**Project:** **Mount Joy Warehouse Park**  
Mount Joy Township, Lancaster County, PA

**Subject:** Transportation Impact Study (TIS) Scoping Meeting

**Draft Scope Application Cycle 1 Comment Sheet**

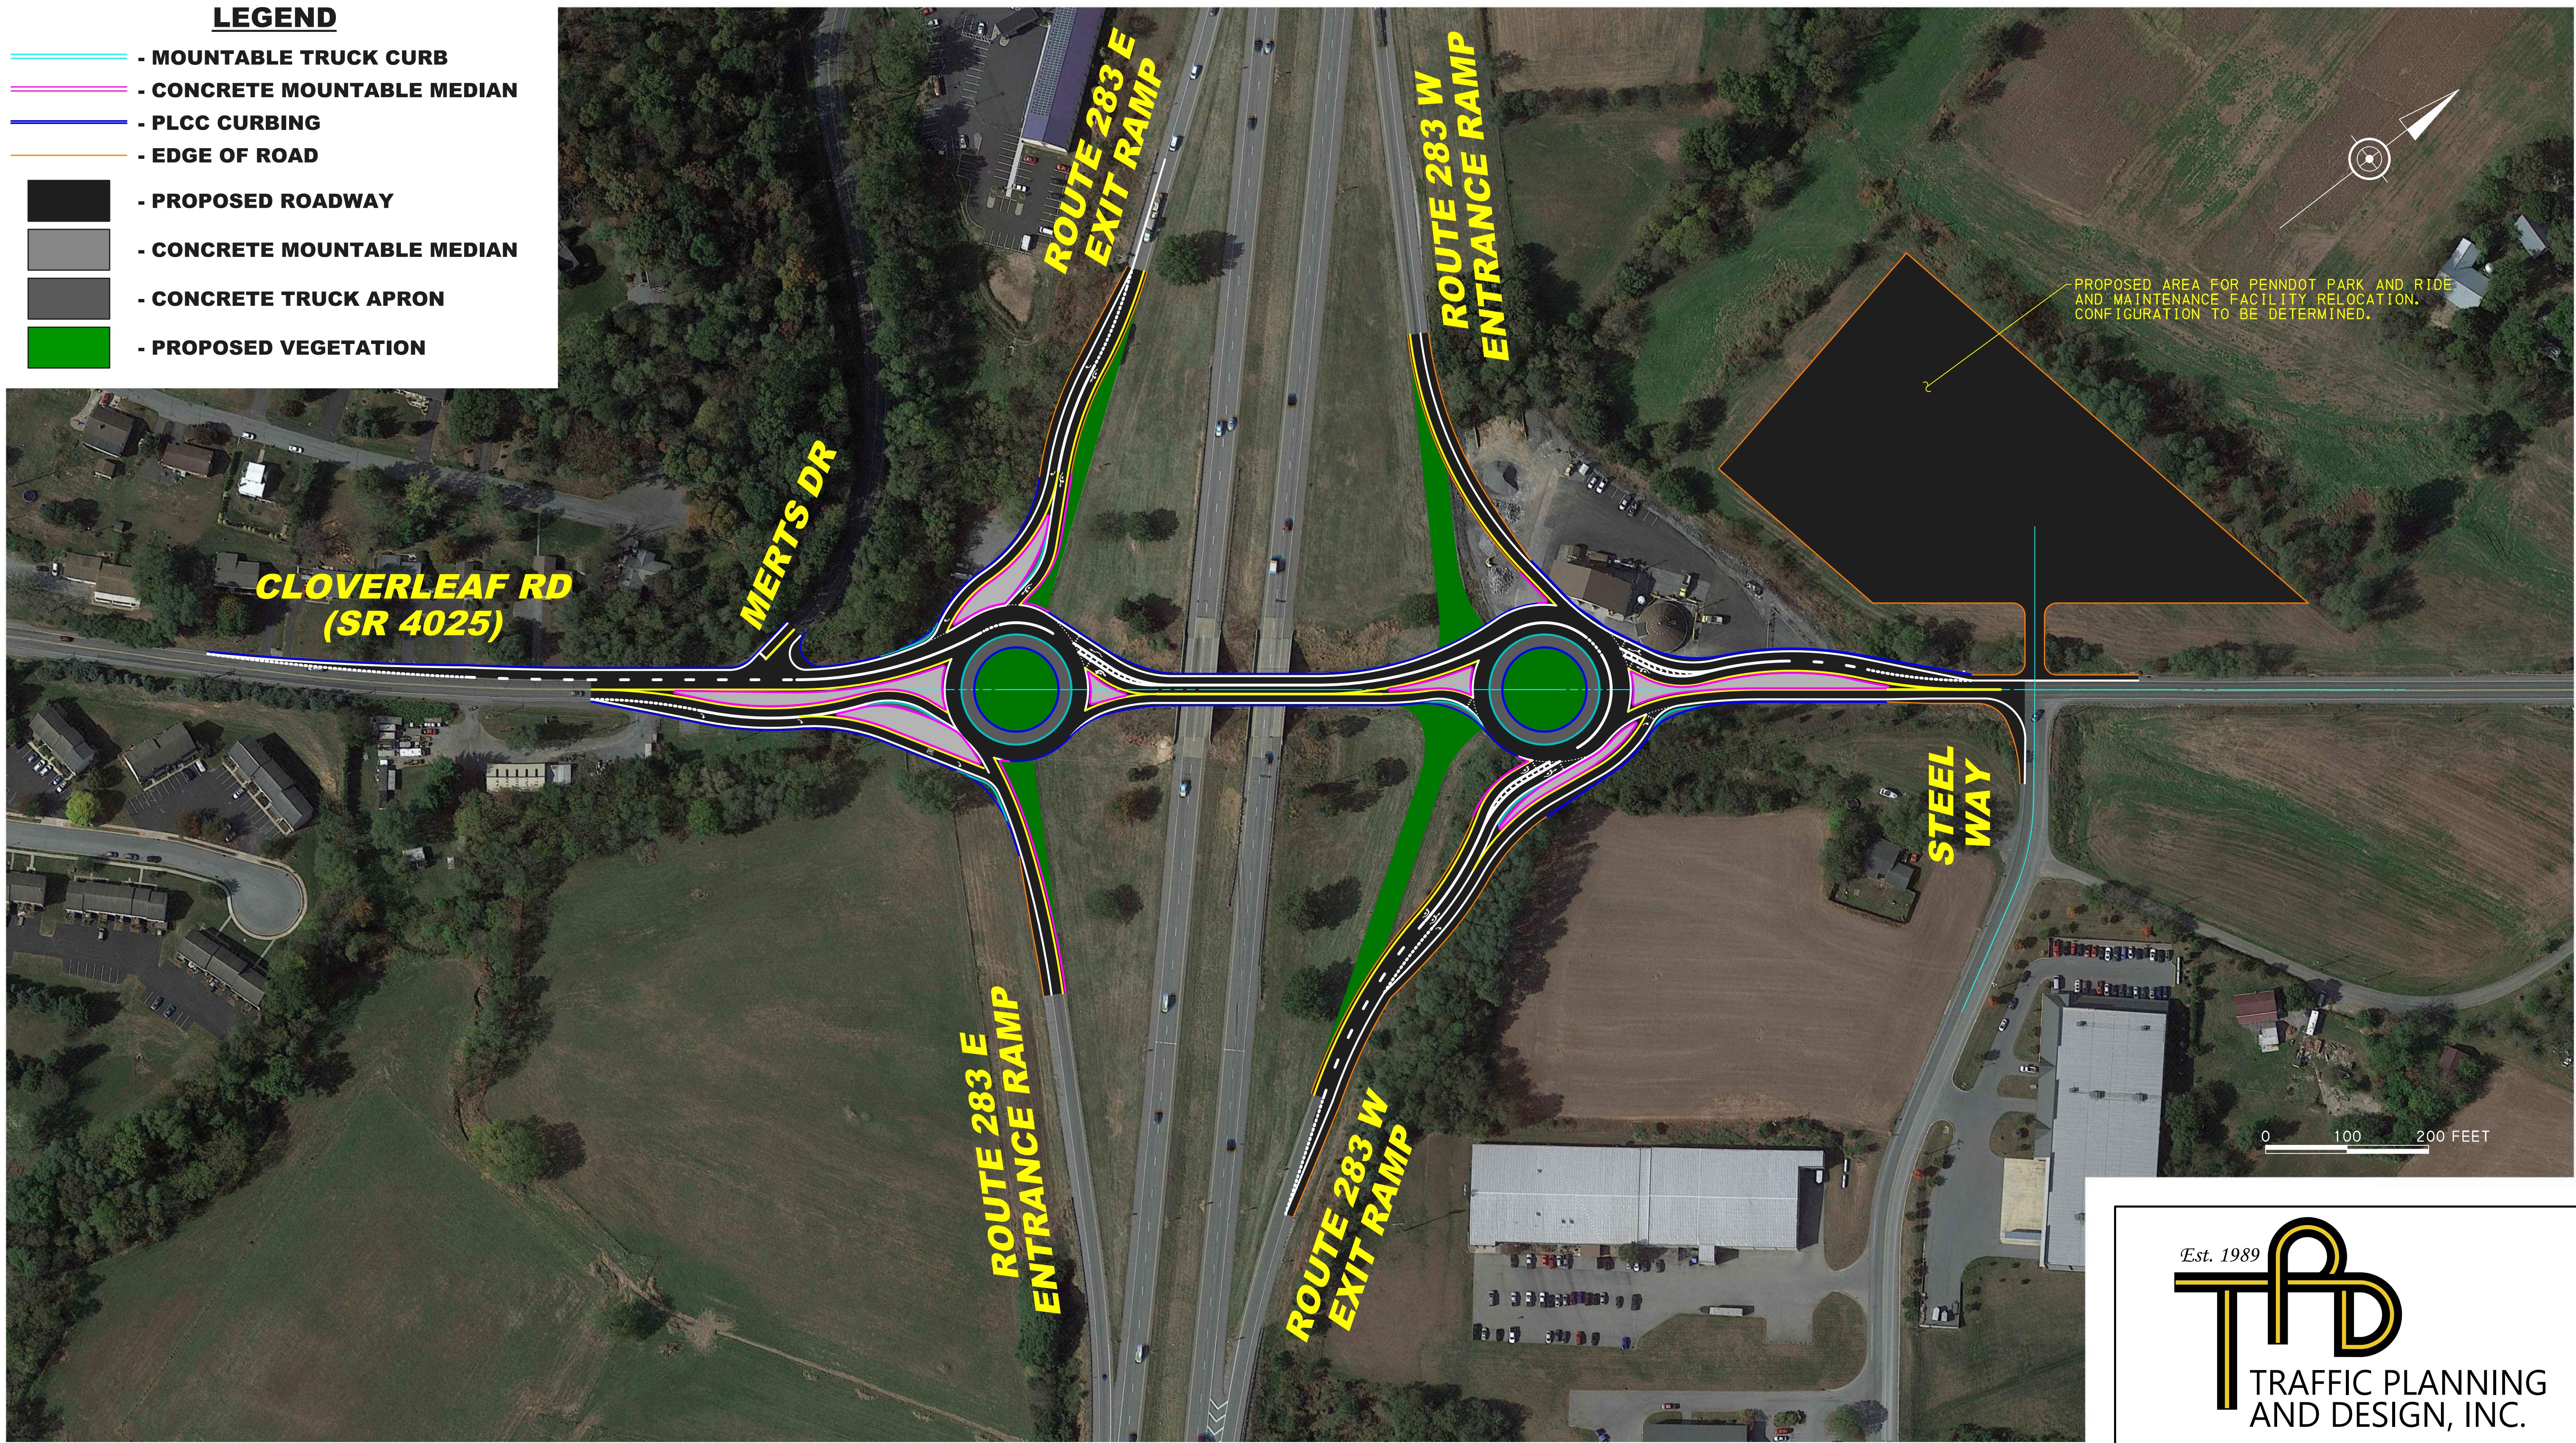
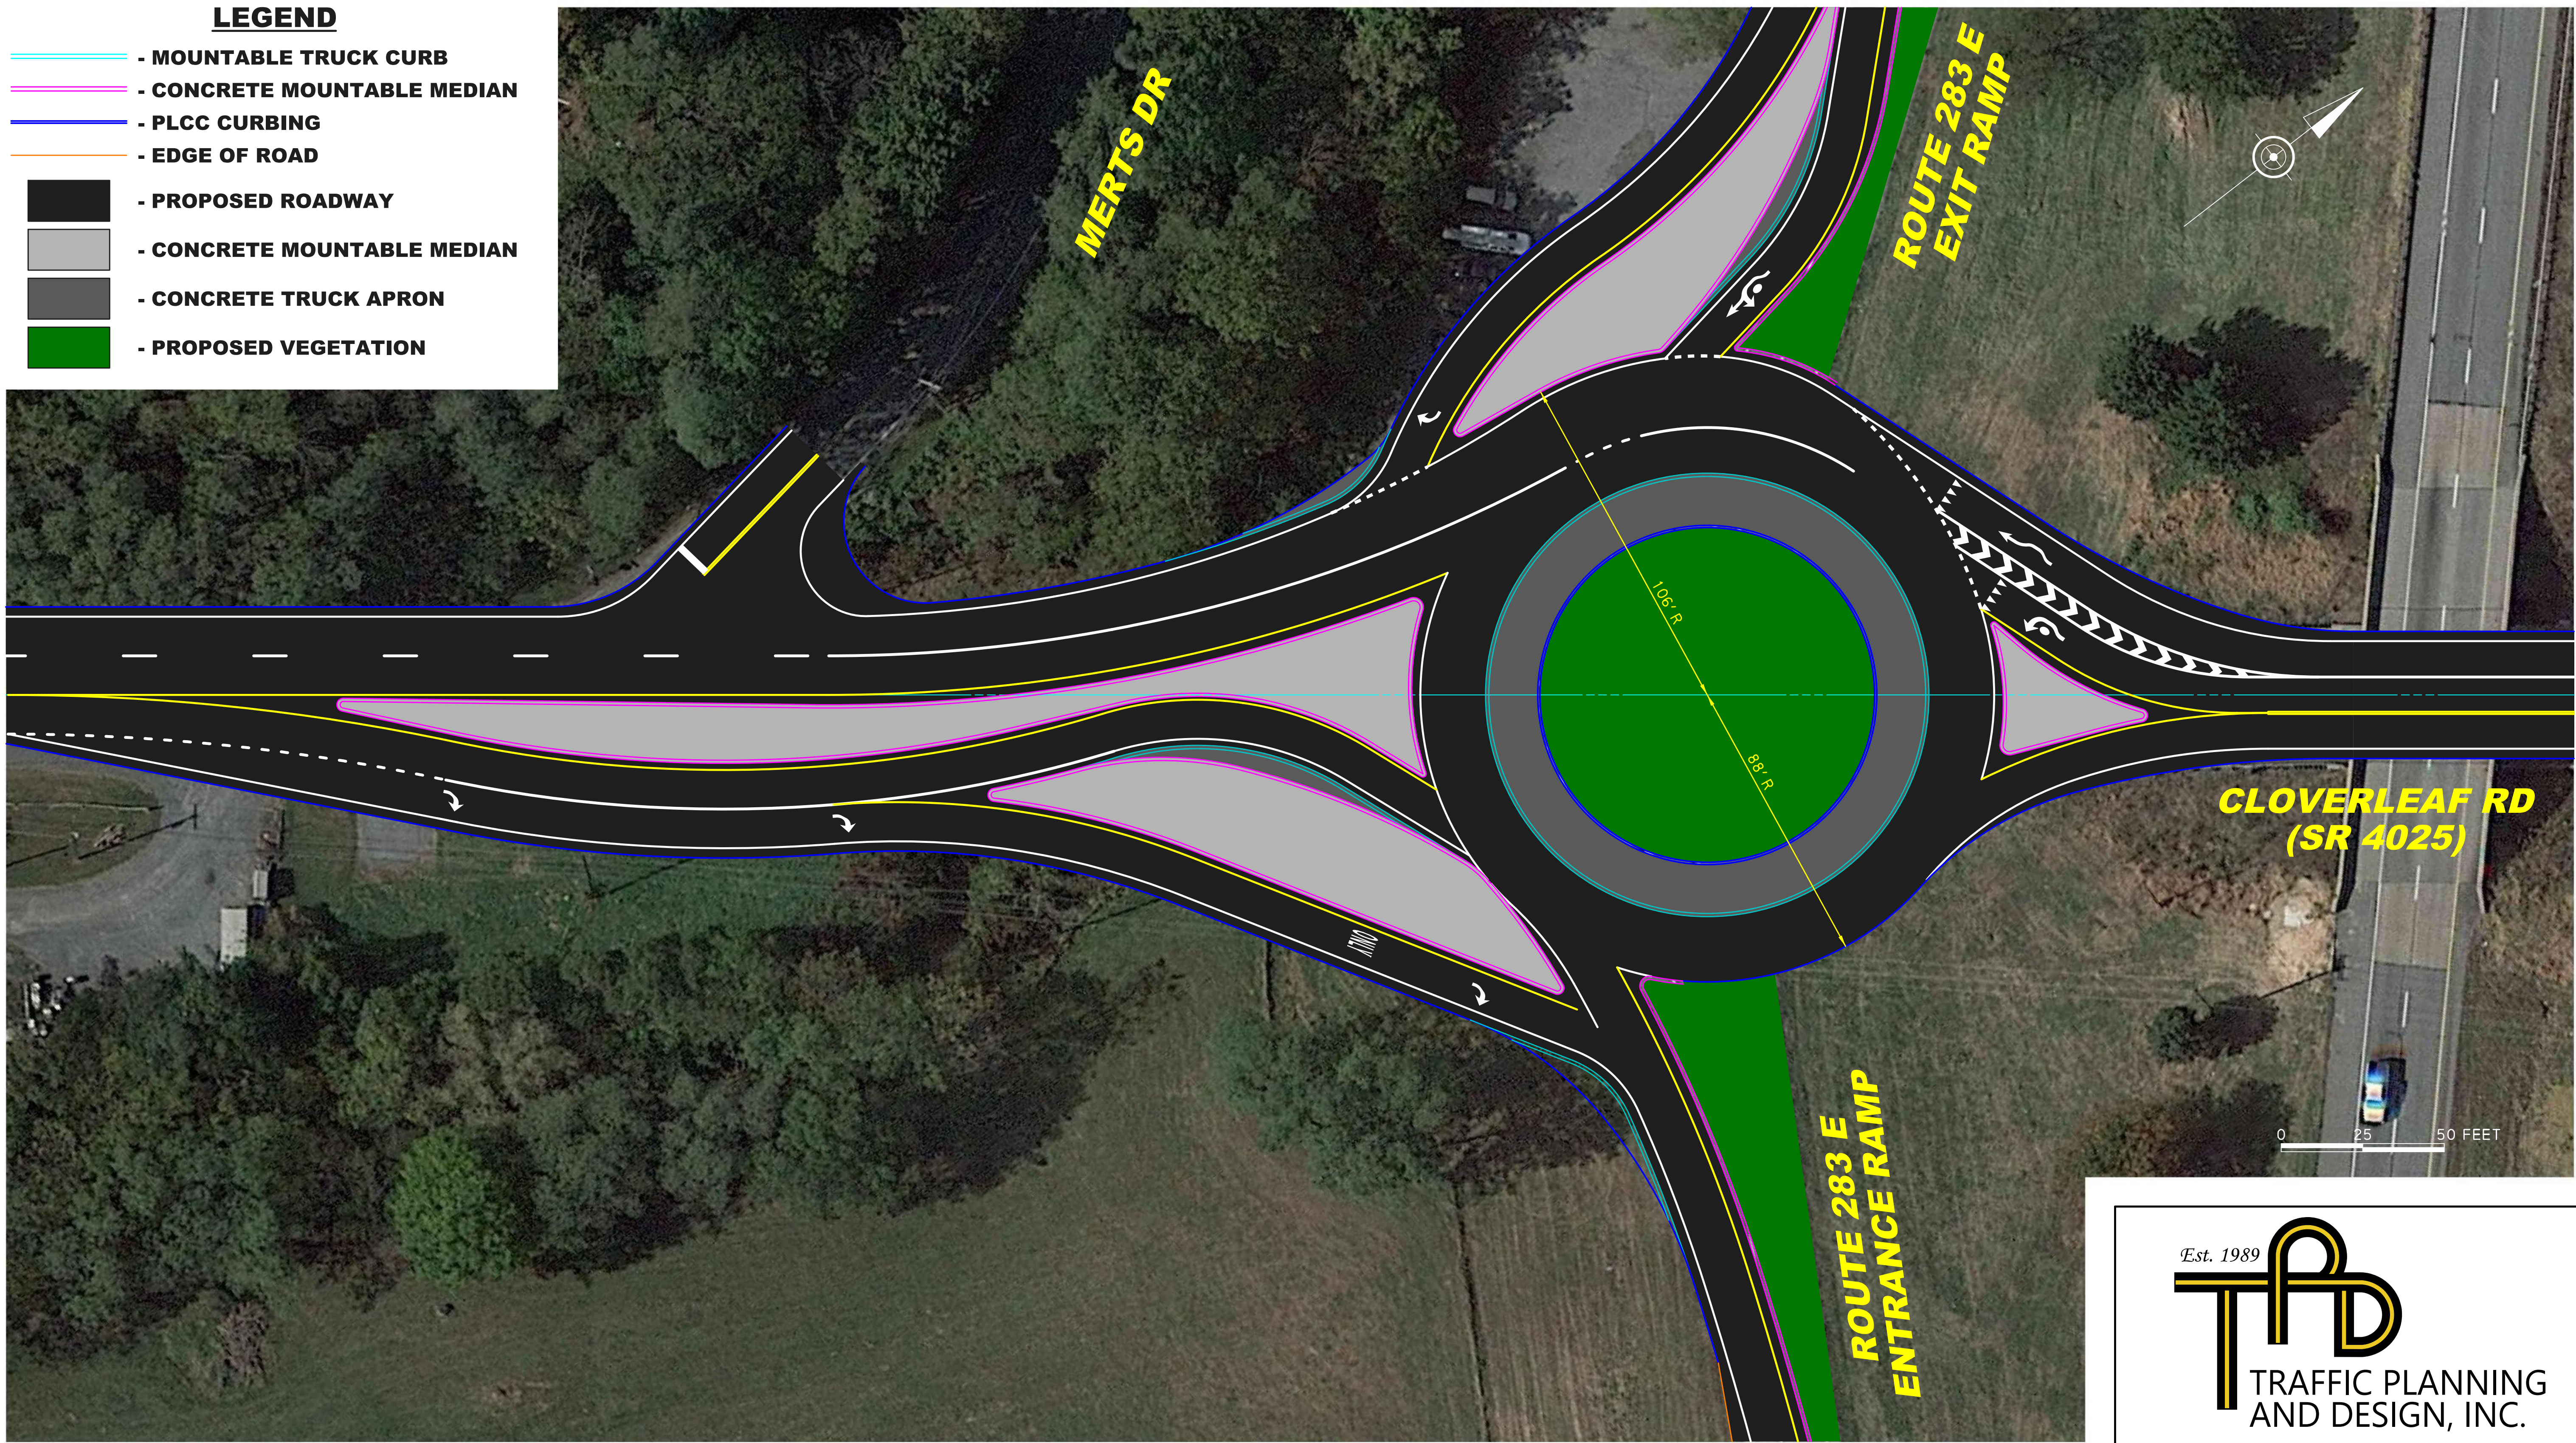
- » Eric Kinard questioned if Jarred ever worked with any development involving PennDOT properties/storage sheds. Bill Warden mentioned to reach out to PennDOT roadway department to discuss the process. Warden questioned if there was an alternate site proposed for PennDOT storage shed. Jarred indicated, Panattoni currently has the parcel of land directly to the north of the shed under option to purchase, the land will be subdivided and dedicated to PennDOT in order to construct the maintenance shed and Park-and-Ride as shown on attachment Concept D1 (orange outline).
